Quality Control Check Report. Stage: After Finishing Stage III (Apartments)

Flat No	A-401	Other	Sl. No.	37862
Company	MPL	Project	Phase	
Prepared by	T. Vinod Kumar	Sign	Date	29-06-21
Project Manager	Subba Reddy	Sign	Date	29-06-21
Previous stage report no.	36646	Report filed and signed by PM	Yes ☒ No ☐	
Checked By MD on	MD Sign	For filling	Yes ☐ No ☐

Company Name:	Modi Properties Pvt Ltd	Site	May Flower Platinum
Name of the customer	Dr. G. Narasimha Rao		
Villa/ Flat No.	A - 401		
Sl.No	Description	Amount	
1	Total extra Charges	6,820/-	
2	Total refundable amount	32,180/-	
3	Net amount to be charges (if any)	-	
4	Net amount to be refunded (if any)	32,180/-	
Remarks :			
Approved by Project Manager		Approved by Design Team	
Date 8/9/2021		Date	
Sign: 		Sign:

Flat No	401	Block no.	'A' ✓
Flat Area	1500 sft	Type	Deluxe / Luxury
Buyer Name	Dr.G.Narasimha rao		
Phone No.	9492656017/9866514375	Email	LION6017@GMAIL.COM

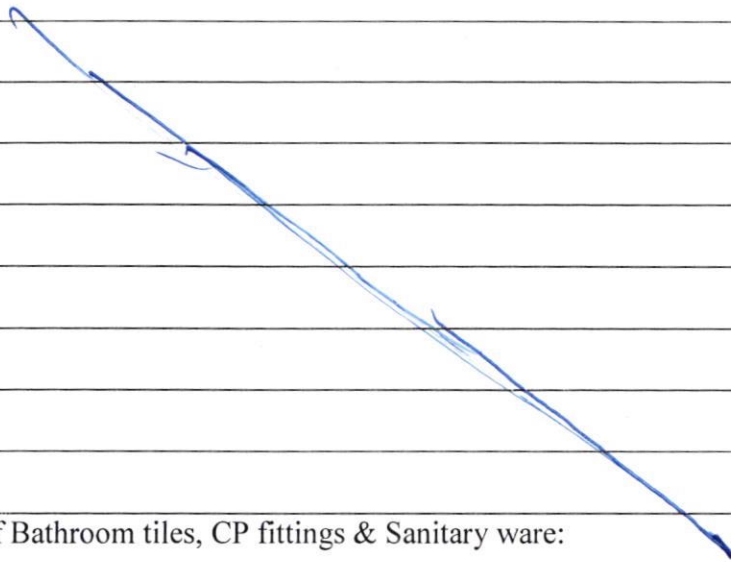
Changes in flooring:

- (i) Drawing room: Matt finishing tiles will be handed over by the ~~vendor~~ flat owner
- (ii) Dining Room, Bedrooms, Balcony, Kitchen - Matt finishing tiles will be handed over by the ~~vendor~~ flat owner

~~iii~~ All tiles will be brought by customer except bathroom tiles, utility tiles.

~~iv~~ 4) A Drawing, kitchen mesh screen window for addition cost.

WORKING DRAWING OF FLAT NO. A-1

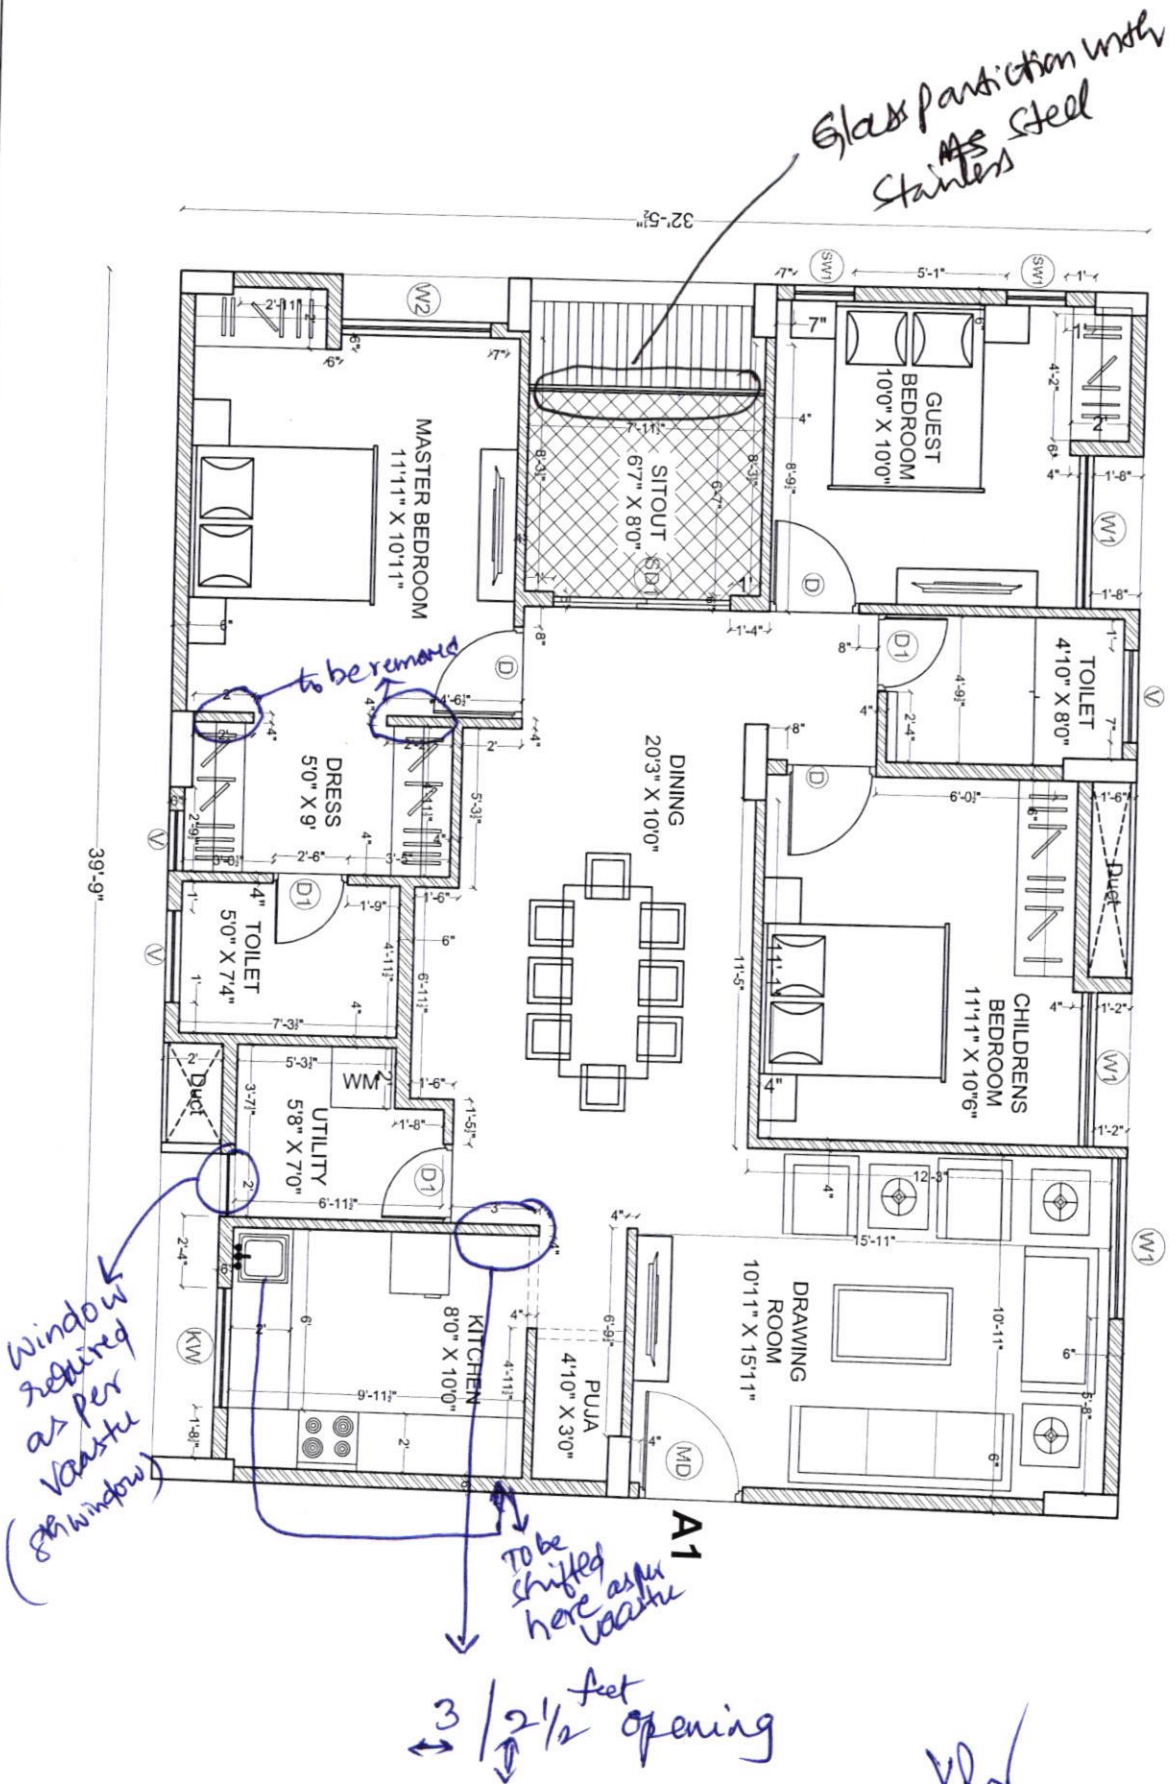
Changes in kitchen platform: (mark on plan)

- Sink in Kitchen to be placed at North east corner
- Wall opening required between Dining area and kitchen. As marked on plan

Other Changes:

- Remove the step provided for washing machine ✓
we want plain flooring in wash area. ✗
- Dress area wall opening required (@ Master Bedroom)
- French window 4 track (upgrade) with Mesh window ✓
- We require plain ceiling in all bedrooms ✓
- Designer Ceiling in Hall and Drawing, Dining area.
~~as per model flat A-105.~~ (Discussed with the ceiling designer Mr. Ismail)
- ~~We don't require lights in Bedrooms~~
- Drawing, Dining Hall (20x10) Ceiling lights (5+5) required
- Window in the wash area to be arranged as 8th

window (as per the other windows specifications)

- Sit out point: We don't want Iron grill, but we require stainless steel with 6 bars partition as outer view

Description	Direction	Owners & Developers :	Date :	Promoted by
PLUMBING PLAN OF A1	N	Modi Properties Pvt. Ltd.	09.01.2020	Modi Properties & Investments Pvt. Ltd.
		Project Name & Phase :	Approved :	
		Mayflower Platinum	Soham Modi	Phone: +91-40-66335551
			Scale :	
			N.T.S

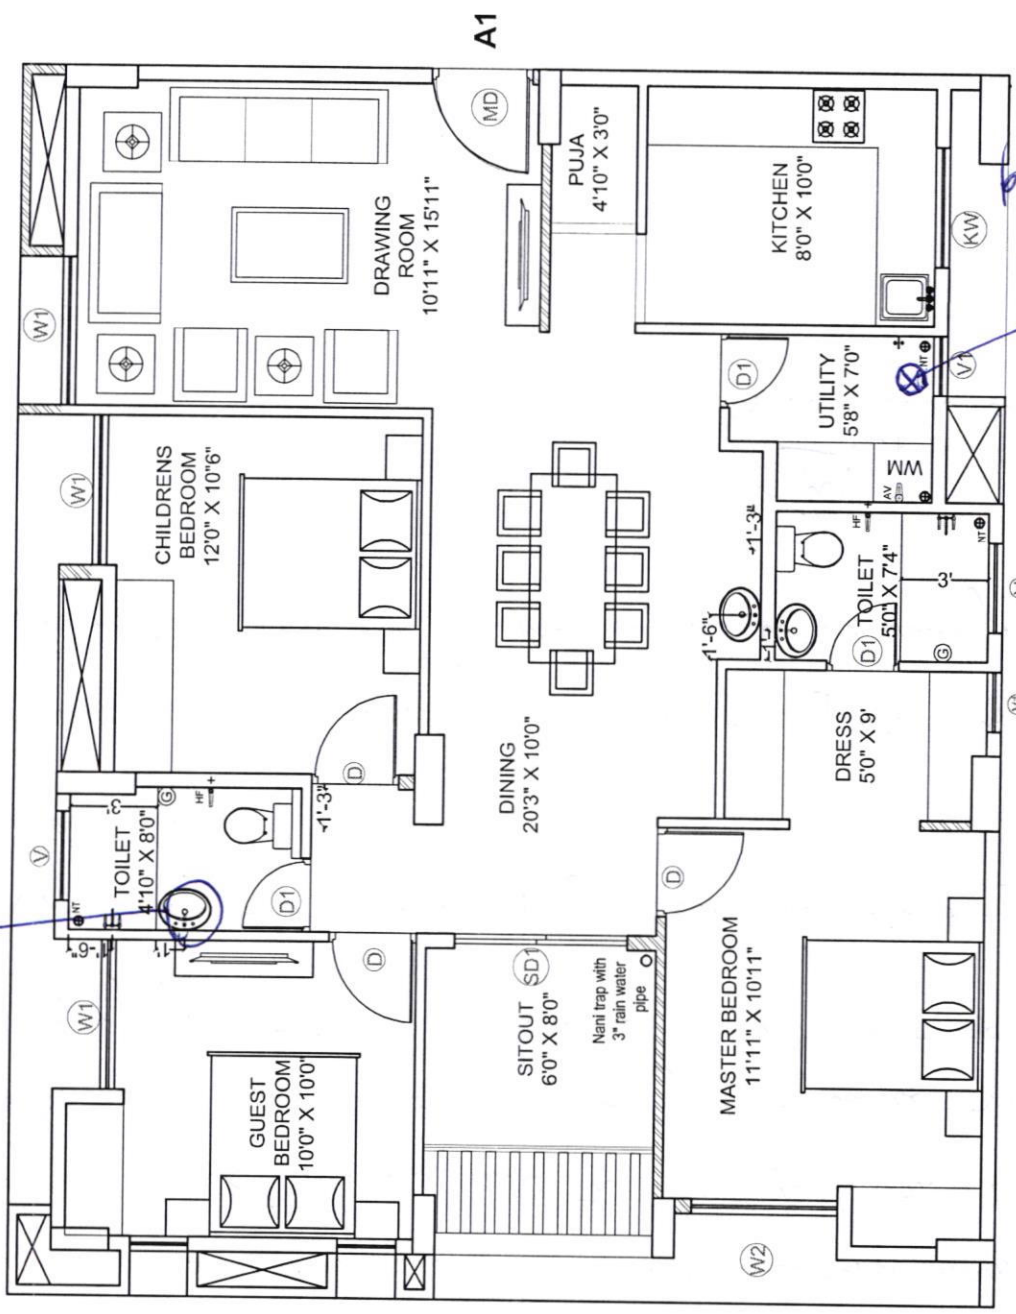
Swachh Banih
 not requiring
 here. But
 keep the
 points.
 this work
 drain to be
 shifted to
 wash area.

Water
 Basin
 Point
 regular
